Amendment-I dated 26.05.2025 to the RFP Documents for selection of bidder as Transmission Service Provider to establish intra-state transmission system for “Establishing 400kV Sub-station at Mekhali along with associated transmission lines (Belagavi District)” through tariff based competitive bidding process.

SPECIFIC TECHNICAL REQUIREMENTS FOR COMMUNICATION

Figure F.2

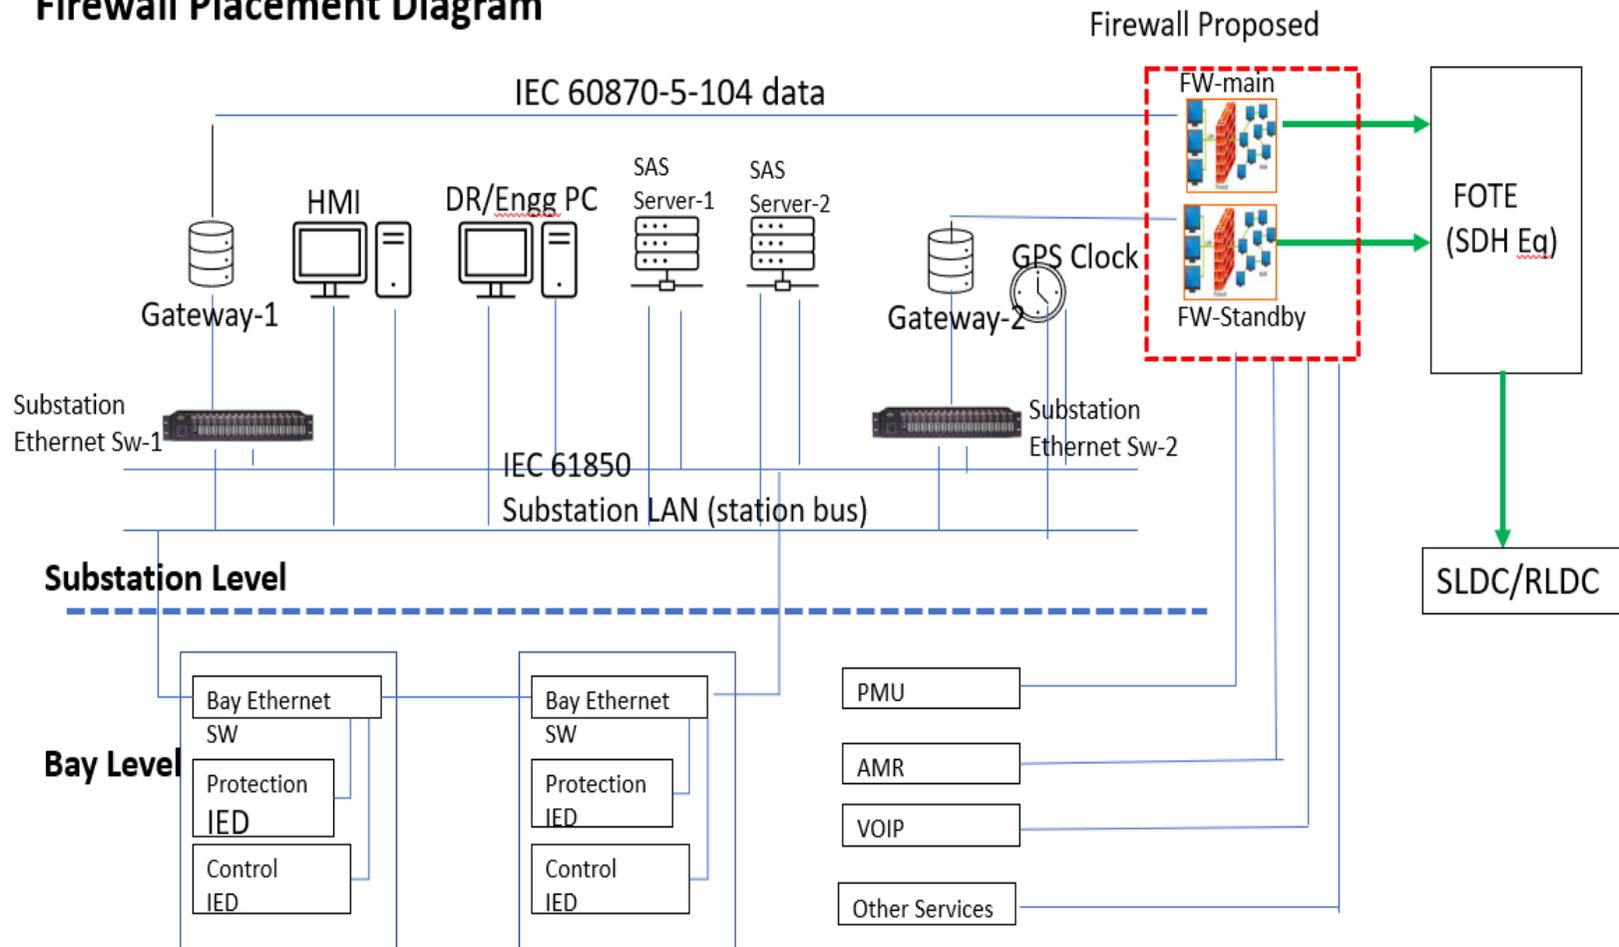
TSP shall provide 2 NGFW one in Main & another in Standby mode having electrical ethernet interfaces/ports and placed between FOTE & SAS gateway/s at the substation. All ethernet based applications shall be terminated in the firewall ports directly (e.g. PMU, AMR, VOIP, SAS/SCADA etc.). Each port of firewall shall work as a separate zone. Firewall shall be hardware based with features of Block/Allow/drop and IPSec VPN (network encryption).

The number of ports/interfaces in each firewall (i.e. Main & Standby) shall be minimum 16 nos. TSP shall provide either single firewall or multiple firewalls to meet this interfaces requirement, each for main as well as standby firewall. Minimum throughput of firewall shall be 300 Mbps.

The specifications for the firewalls are given at **Annexure F.2** and schematic diagram showing firewall placement given at **Figure F.2**.
